REINFORCED ELASTOMERIC BEARING FABRICATION SHEET 1103- Page #: 1

Project #: 38760-1103-1 (16 OF 16) Customer: J A MCDONALD (PO # 101912)

County: ESSEX State: VT Structure: BRIDGE 84

Vermont Agency of Transportation
RECEIVED
CK'D BY JTS OK'D BY WDL
December 6, 2012
RESUBMIT BY KMH APPROVED AS NOTED 12-20-12

A PLAN
NOT TO SCALE

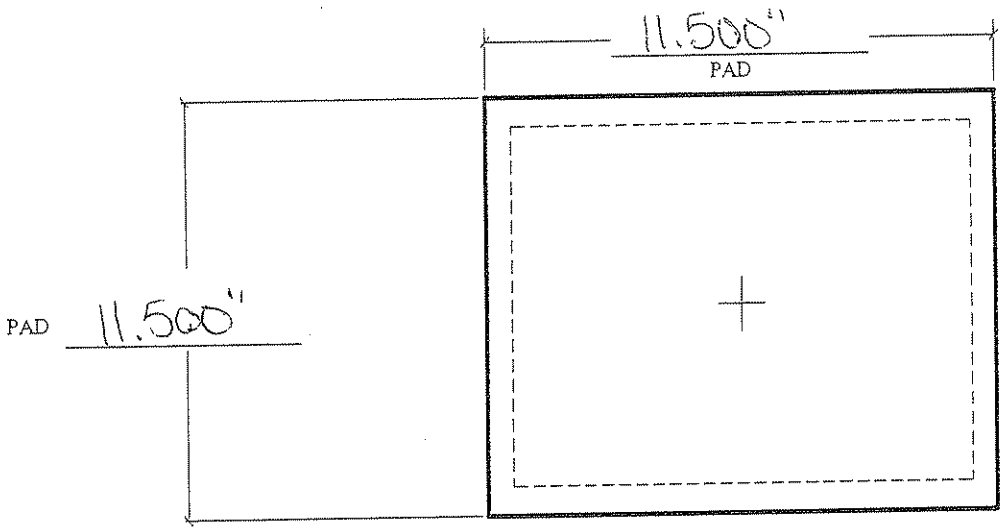
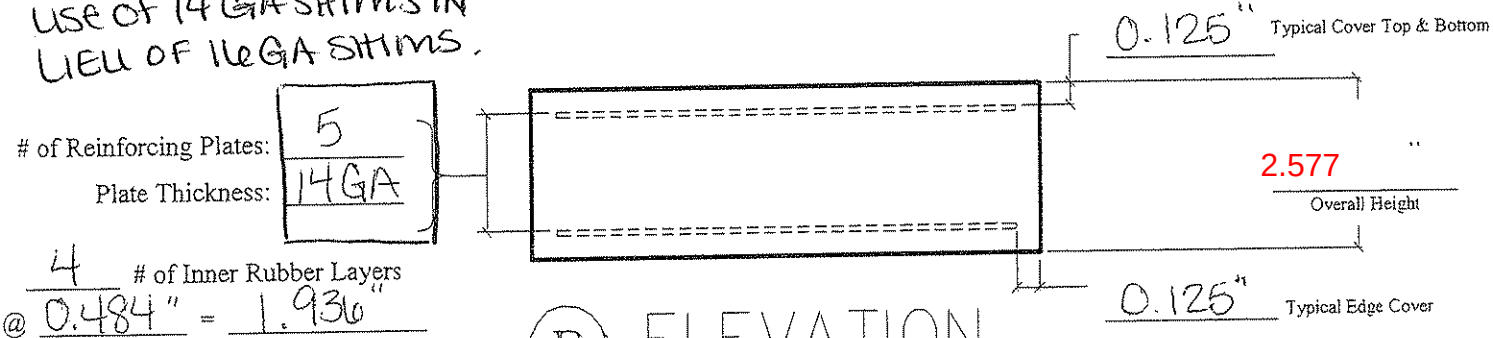
Please verify the use of 14 GA SHIMS IN LIEU OF 16 GA SHIMS.
